## **Appendix A**

### **Review of Public Comments Received by the TWDB**

The United States Geological Survey, in cooperation with the Texas Water Development Board, has completed a groundwater availability model for the northern portion of the Gulf Coast Aquifer System (Ellis and others, 2023). This model meets TWDB modeling, public comment, and stakeholder involvement standards. Therefore, this model is now the current groundwater availability model for the northern portion of the Gulf Coast Aquifer System. This appendix is ancillary to the model report, and contains the public comments received and responses to those comments. The model report can be found at <https://pubs.usgs.gov/publication/pp1877> or [https://www.twdb.texas.gov/groundwater/models/gam/glfc\\_n/glfc\\_n.asp](https://www.twdb.texas.gov/groundwater/models/gam/glfc_n/glfc_n.asp).

### Lone Star Groundwater Conservation District (LSGCD)

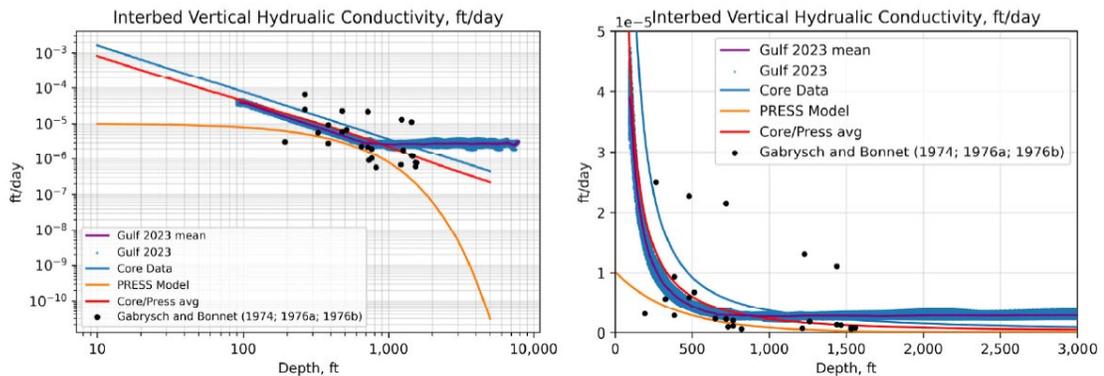
6. [comment 6] “In Figure 98.B. of the report, Ellis and others (2023) present the vertical hydraulic conductivity of fine-grained units as:

As easily observed on the log scale figure, below depths of about 700 feet the vertical hydraulic conductivity of the fine-grained units in the model files is essentially constant to slightly increasing which is inconsistent with the core data and PRESS models average proposed by Kelley and others (2018). Ellis and others (2023) should describe their justification for diverging from the referenced conceptual model within the numerical model.”

*Response: The GULF model interbed vertical hydraulic conductivity conforms with the Gabrysch and Bonnet (1974, 1976a, 1976b) core data. The subsidence observations and simulated subsidence, vertical displacement, and compaction in the model are in good agreement as shown in report figures 139–174.*

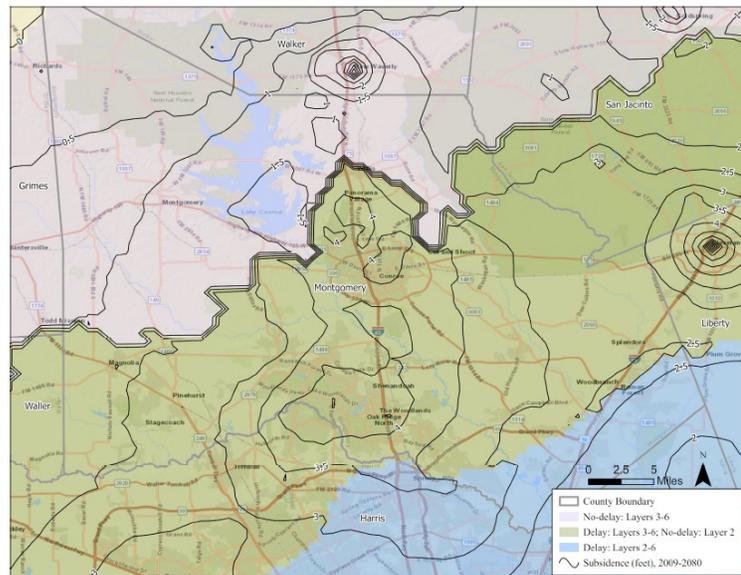
We evaluated results from the model in a manner consistent with the approach used by GMA 14 during the most recent round of joint planning by calculated average subsidence per county and percent remaining available drawdown. Average subsidence per county in the GMA 14 DFC run (HAGM) was 0.6 feet, with the largest amount of simulated subsidence being 2.23 feet in Fort Bend County (see Table below). For the Gulf 2023 predictive run using the same annual pumping volumes per model layer, the predicted subsidence increased in every county (except Galveston) with the average subsidence value increasing to 1.29 feet and a maximum amount of 2.71 feet in Fort Bend County. The greatest amount of increased predicted subsidence occurred in Montgomery County where it went from an average additional subsidence amount of 0.55 feet in the GMA 14 DFC Run (HAGM) to 2.28 feet in the Gulf 2023 predictive simulation.

We also calculated the median percent available drawdown using the same well database used in the GMA 14 DFC Run. The aquifer assignments in the well database were also maintained. The median percent available drawdown was calculated per county, resulting in an overall decrease of 12% between the GMA 14 DFC Run and Gulf 2023 predictive run. Like the average subsidence results, for nearly every county the median percent remaining available drawdown decreased with the same annual pumping volume per layer.

Based on the posterior ensemble results shown by Ellis and others (2023) and the results shown above, Gulf 2023 use in joint planning could result in a reduction in available groundwater with the same DFCs adopted by GMA 14 during the previous round of joint planning. With the implications for joint planning, the authors should discuss the reliability of model predictions with regard to determining the amount of groundwater available for regional water planning.”

*Response: A probabilistic approach was used to assess the uncertainty in the modeled results. Uncertainty in the results is related to uncertainty in the model, such as simplifications of the modeled natural system, spatial and temporal discretization, or uncertainty in the hydraulic parameter value estimates. Additionally, the process of inverse modeling, whereby parameter values are estimated from a limited amount of data, produces non-unique solutions. Thus, the model outputs can be viewed as more “probabilistic” than “deterministic” and may have a range of possible results. By exploring different combinations of likely parameter distributions—which correspond to possible scenario outcomes—the uncertainty can be expressed numerically using an ensemble. GULF report page 202 describes an overview of the probabilistic modeling workflow represented by the accompanying ensemble. Additional discussions of the ensemble are provided in GULF report pages 212, 216, and 218–222.*

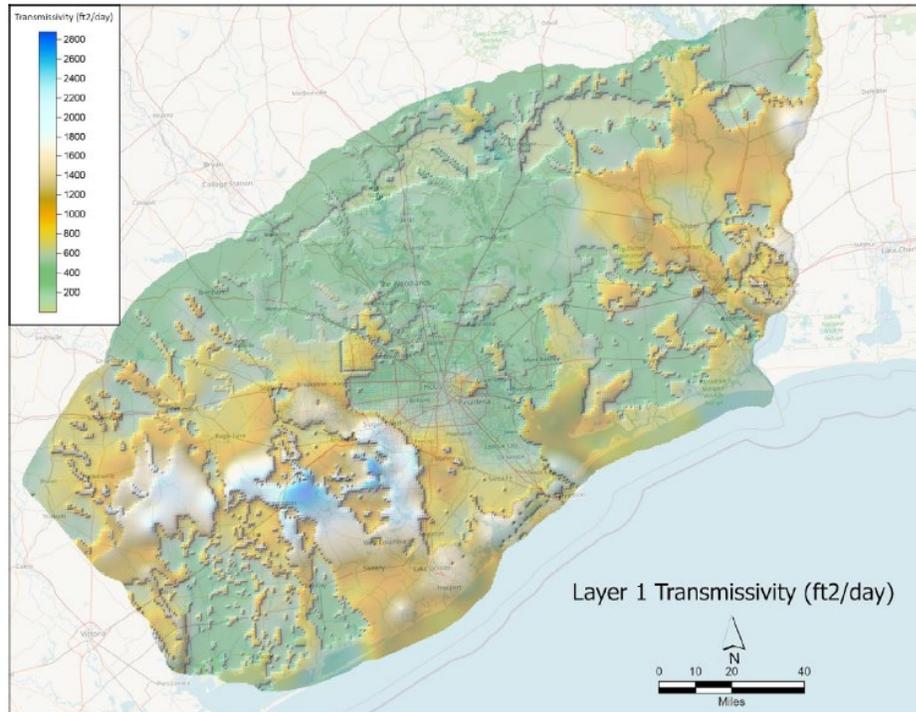
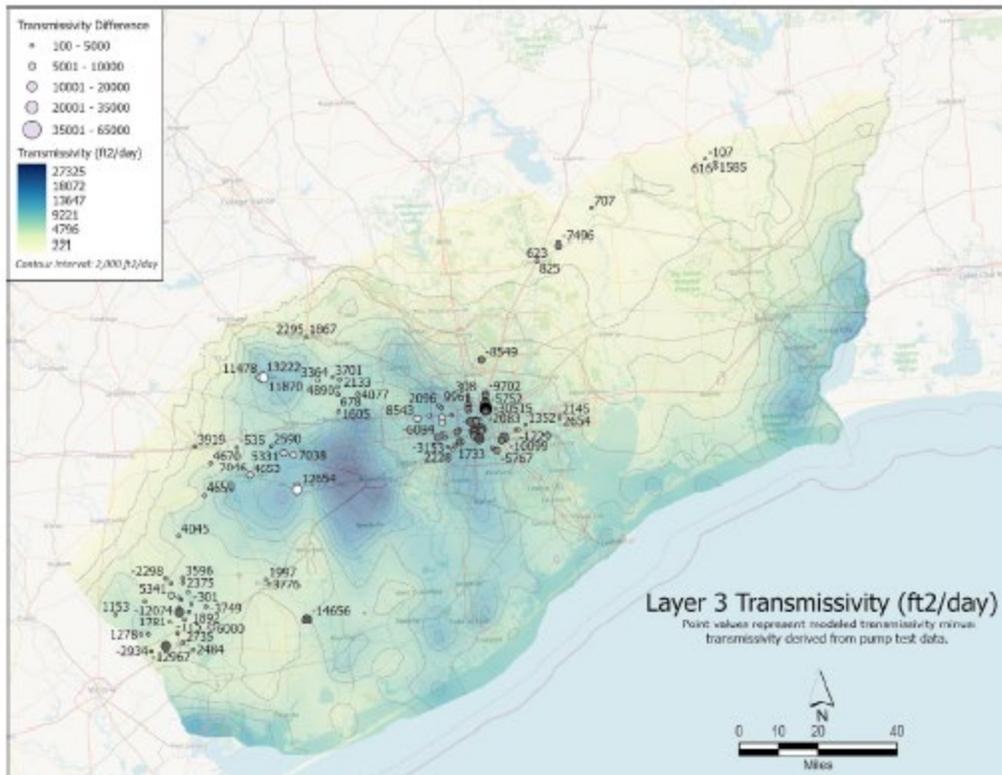
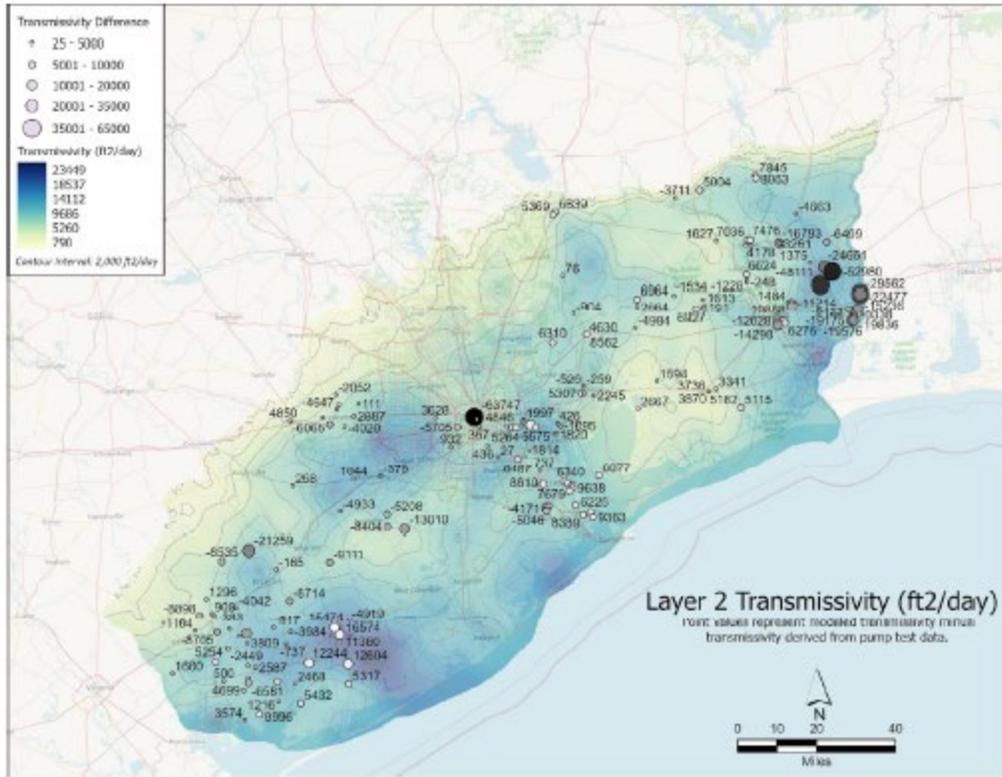
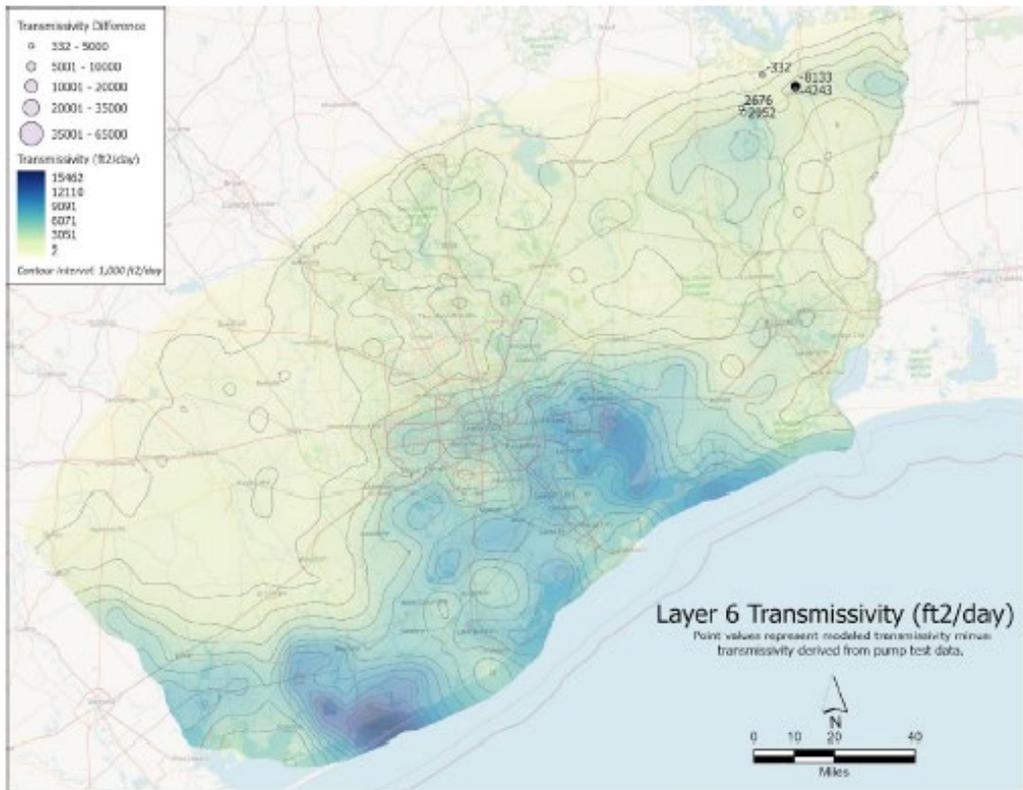
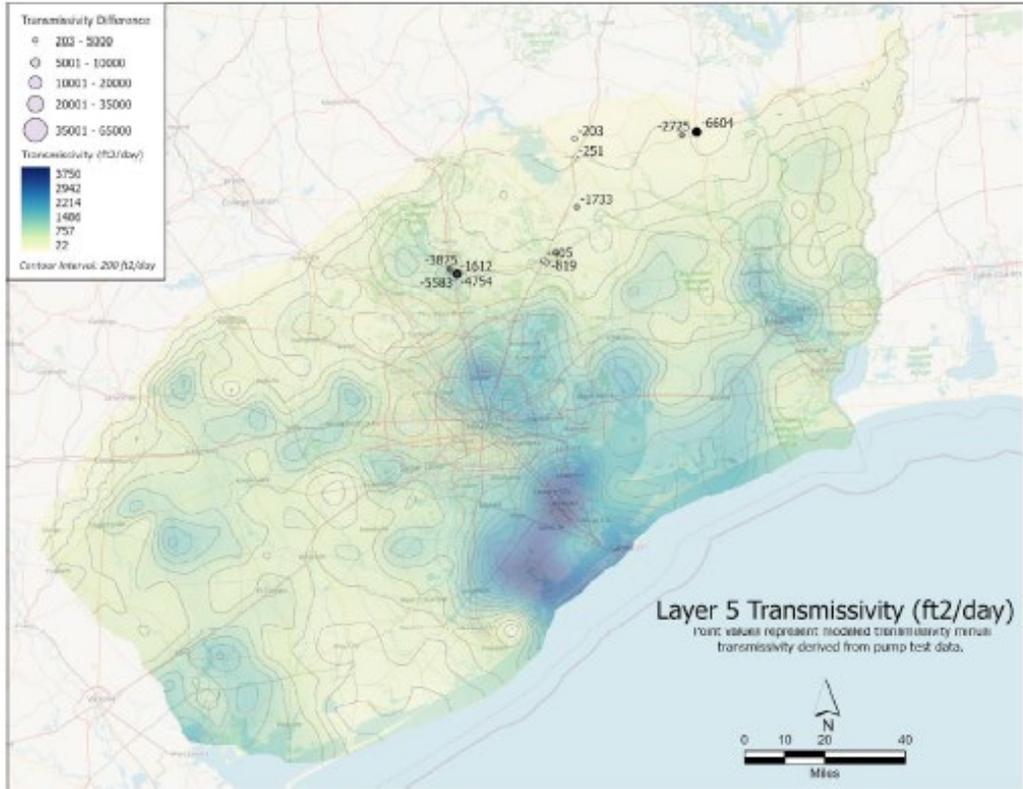
[comment 10] “Accurate predictions of aquifer responses to hydraulic stress require accurately applied transmissivity values to model layers. In general, the modeled aquifer transmissivities do not appear to be consistent with published pumping test data (TWDB Reports 98 and 381). The following figures show the aquifer transmissivity distribution assigned to the model layers and the deviation from the transmissivity values derived from pumping tests performed on wells constructed in the various aquifers. As shown, there are instances in which the modeled transmissivity differs from published values by thousands of square feet per day and, in the case of Layer 2 (Chicot), the modeled values diverge by tens of thousands of square feet per day from published data. These discrepancies not only affect simulated horizontal flow but, because modeled vertical conductivities relate to the

horizontal conductivities (which are a function of transmissivity), also negatively impact the accuracy of vertical flow and subsidence calculations. It appears that, unlike Layers 2 through 6, the transmissivity applied to Layer 1 does not transition smoothly between regions, which will affect the simulated behavior of the shallow sediments. The figure below is formatted differently from the figures depicting the transmissivity distribution for underlying layers in order to highlight the abrupt transition between zones of transmissivity applied to Layer 1. The differences in the methodologies employed to assign/distribute the hydraulic parameters for Layer 1 should be discussed in the report.

*Response: This is a combined response for the transmissivity questions. When evaluating a model, examining the horizontal hydraulic conductivity as opposed to the transmissivity removes the complication of evaluating the unit layer thickness simultaneously. The layers are substantially thick and include many clay lenses that would not be screened by production wells where transmissivity has been determined. The calibrated horizontal hydraulic conductivity values used in the model are reasonable and align with published horizontal hydraulic conductivity values used in groundwater models across the Gulf Coast Aquifer System.*

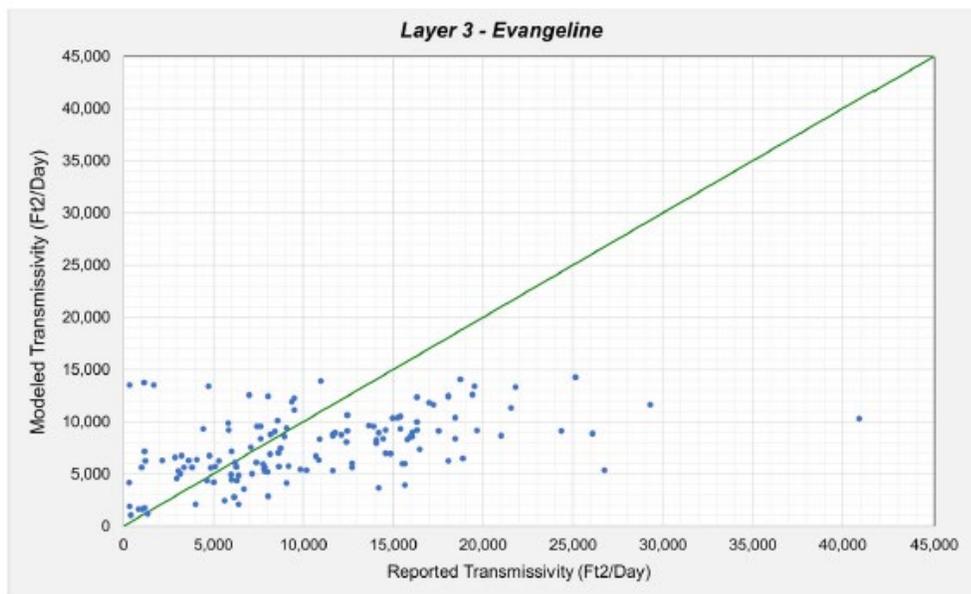
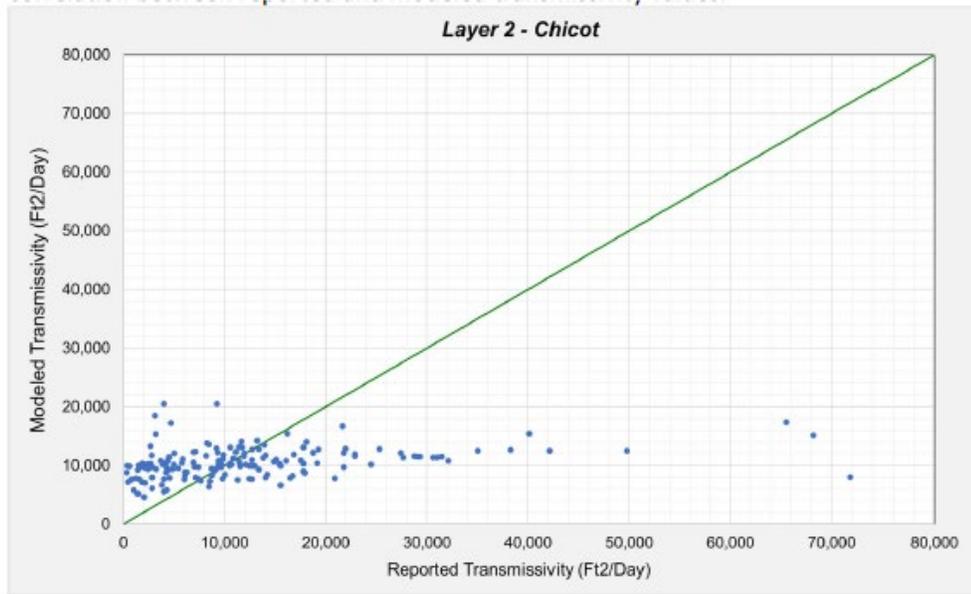
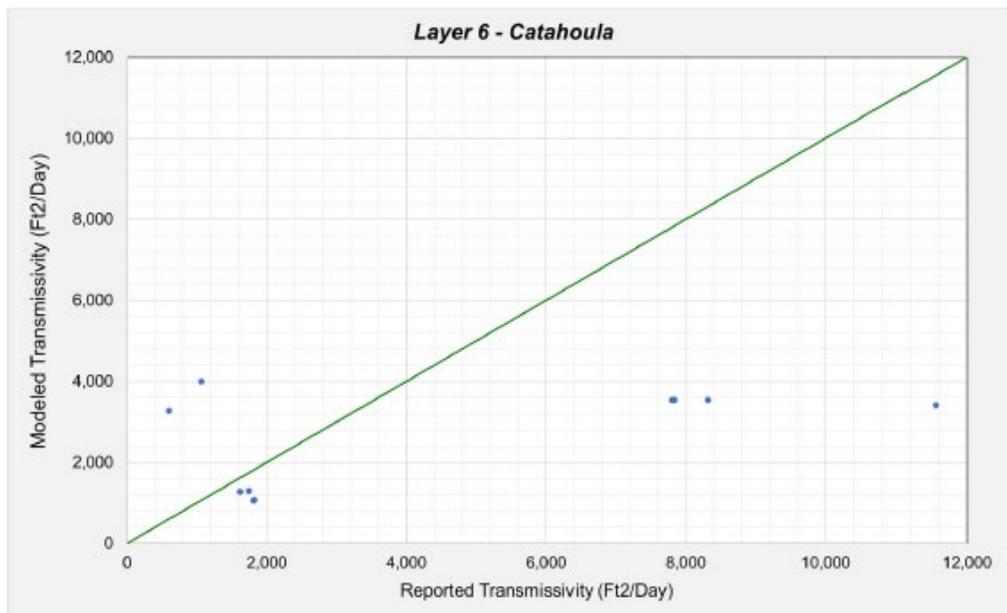
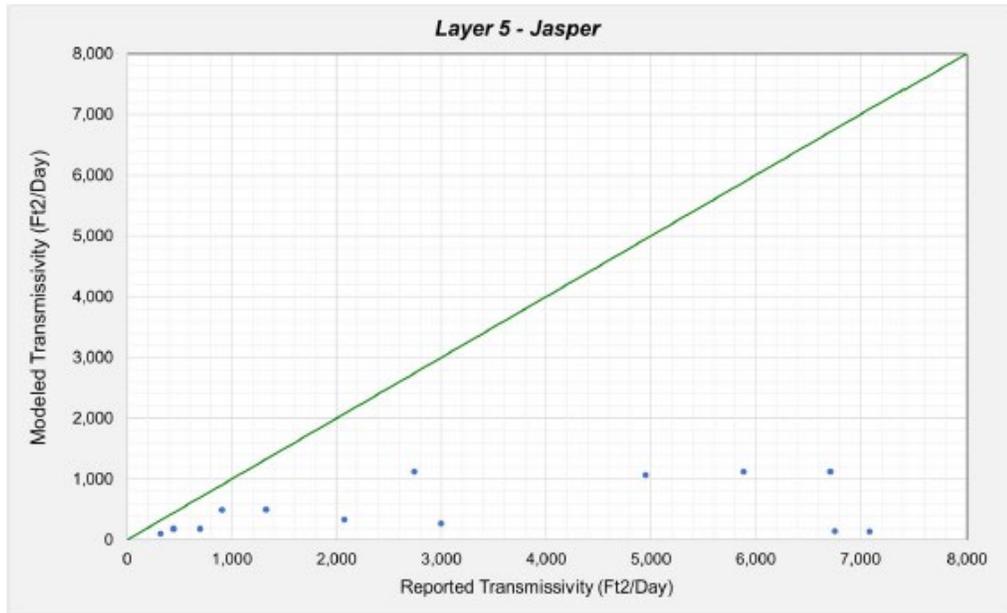
[comment 11] This comment represents a continuation of the previous comment regarding measured versus modeled transmissivity. As shown in the following plots, the modeled aquifer transmissivity correlates poorly to published aquifer test results. Where modeled values reasonably correspond to reported values, the plotted points will fall on or near the green diagonal; however, the plotted trends do not express the modeled-to-reported correlation expected in an adequately constructed and calibrated model. Ellis and others (2023) should discuss the apparent poor correlation between reported and modeled transmissivity values.

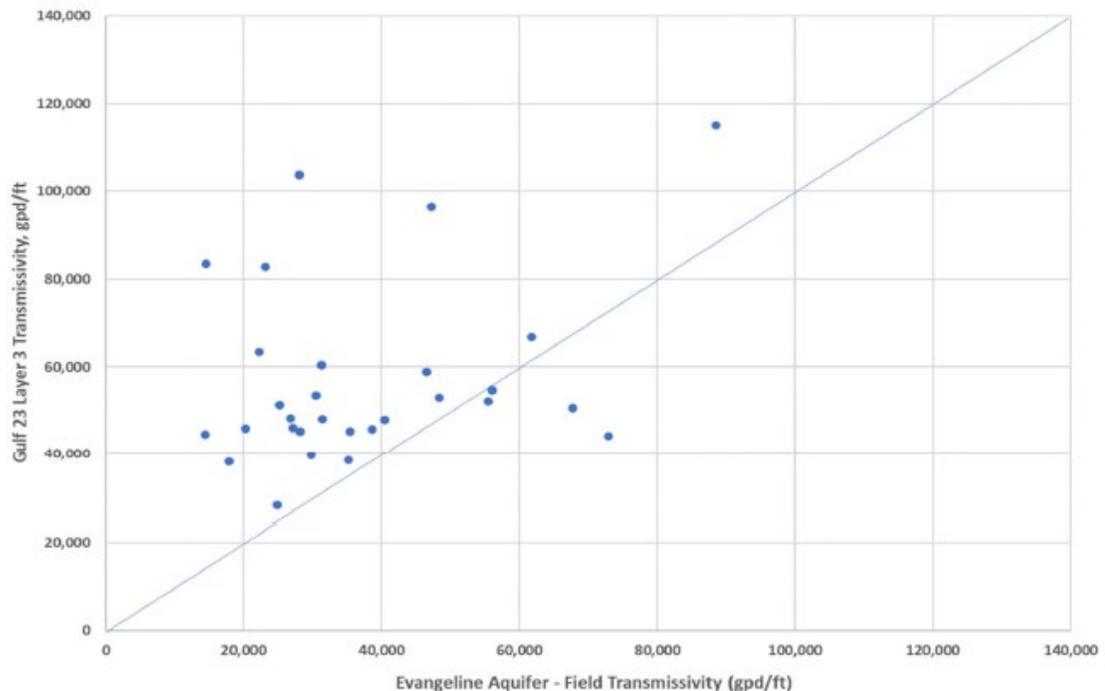
The Gulf 23 Layer 3 (Evangeline Aquifer) transmissivity values appear to be reasonable in the vicinity of the Harris / Montgomery County line. The Gulf 23 transmissivity values for Layer 3 in west central Harris County appear to be higher than what typically has been estimated from the pumping tests of large capacity water wells.

The Layer 3 transmissivity map shows very high transmissivity values in west and northwest Fort Bend County. The approximate location of the Orchard Dome in west Fort Bend County is shown on the Layer 3 Transmissivity map. The shallow Orchard Dome penetrates up through and thins both the Evangeline and Chicot Aquifers with the top to the caprock at a shallow depth of less than 300 feet. The sand thicknesses and the transmissivity values of both the Chicot Aquifer and Evangeline Aquifer are reduced significantly over and in the general area of the dome. What is the basis of the very high transmissivity values in west and northwest Fort Bend County?

The Evangeline Aquifer one-to-one plot above compares transmissivity values in the Gulf23 model (Layer 3) to estimated transmissivity values derived from field testing of large capacity water wells completed in the Evangeline Aquifer. The field data are from large capacity water wells located in Montgomery, Harris and Fort Bend counties. The plot shows that the Gulf23 Layer 3 transmissivity values appear to be generally on the same order of magnitude as the field transmissivity estimates, but the Gulf23 transmissivity values appear to be generally higher than the field estimated data at these pumping test locations.
